NOTICE OF A TYPE II DECISION ON A PROPOSAL IN YOUR NEIGHBORHOOD

CASE FILE NUMBER: LU 08-117518 AD

Case Type: AD, Adjustment

1 SITE PLAN / ROOF PLAN-ZONING
 SCALE: 1/8" = 1'-0"

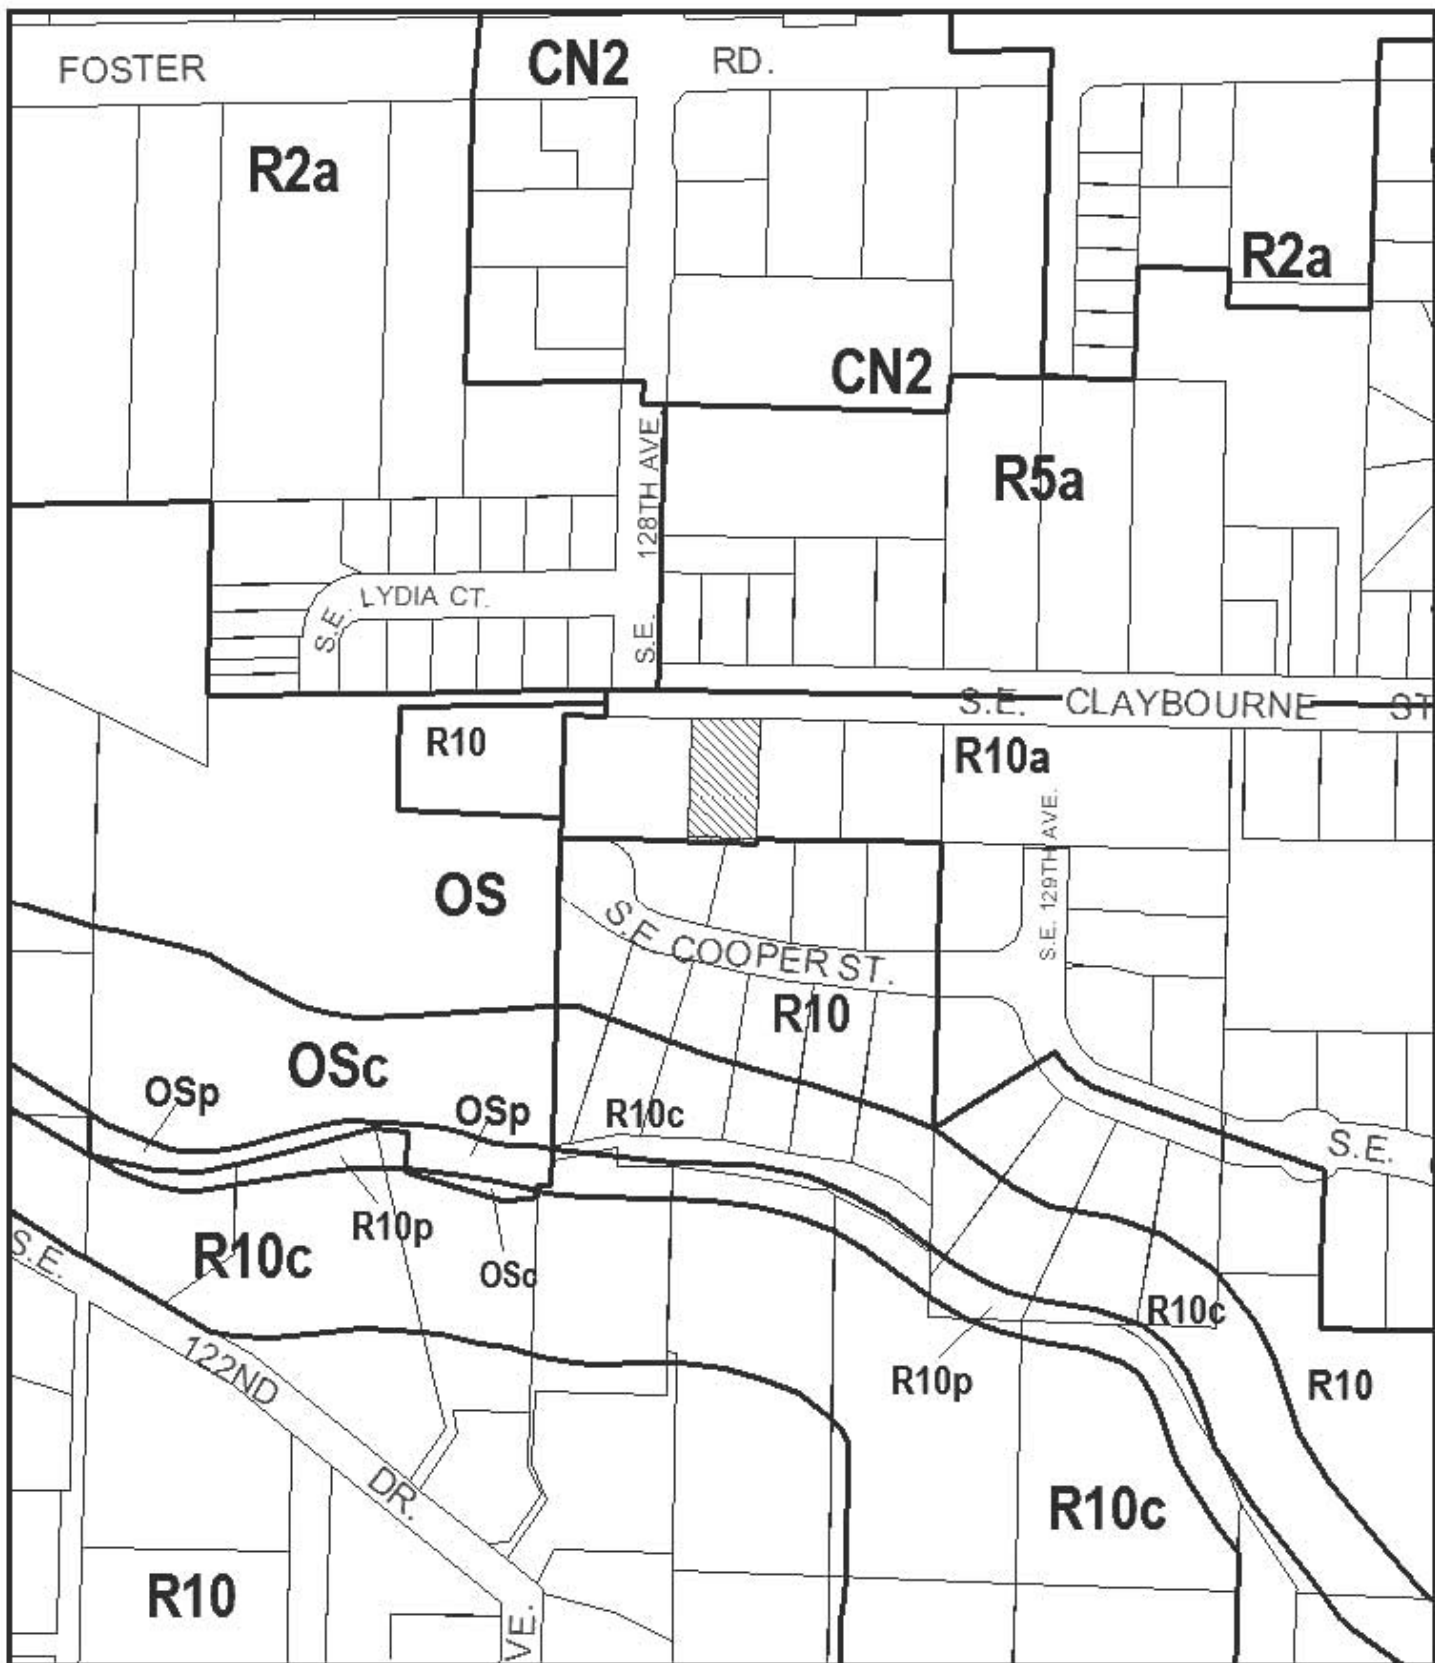
The site plan shows a landscaping bed in front of the street-facing garage wall, which will further add interest to that façade. There is over 12 feet between the east (rear) wall of the garage and the east property line which will also provide landscaping area, and at a minimum a tree and a few shrubs in that east side of the site will also add visual interest from the street. Consequently, a condition will be required to fully meet this criterion that at least one tree is planted adjacent to the east side of the garage, and at least three shrubs between the front property line and the front (north side) of the garage. Because the site is in the Johnson Creek Basin Plan District, the required tree and shrubs must be native species. The tree and shrubs can be of any size as desired by the owner/applicant. With this condition, this criterion will be met.

- B. The following plantings are required: at least one tree adjacent to the east side of the garage, and at least three shrubs between the front property line and the front (north side) of the garage. Because the site is in the Johnson Creek Basin Plan District, the required tree and shrubs must be native species. The tree and shrubs can be of any size as desired by the owner.

- C. The 5-foot walkway leading to the front entrance must be paved with either a dyed and stamped concrete that is of a contrasting color from the concrete driveway, or with paving stones that are natural or manufactured, that are of a contrasting color from the driveway.

Approval of an Adjustment to zoning code section 33.110.253 F to allow the garage to be closer to the front property line than the longest street-facing wall of the house. This approval is subject to the approved site plan and north elevation drawing, Exhibits C-1 and C-2, signed and dated May 9, 2008, and to the following conditions:
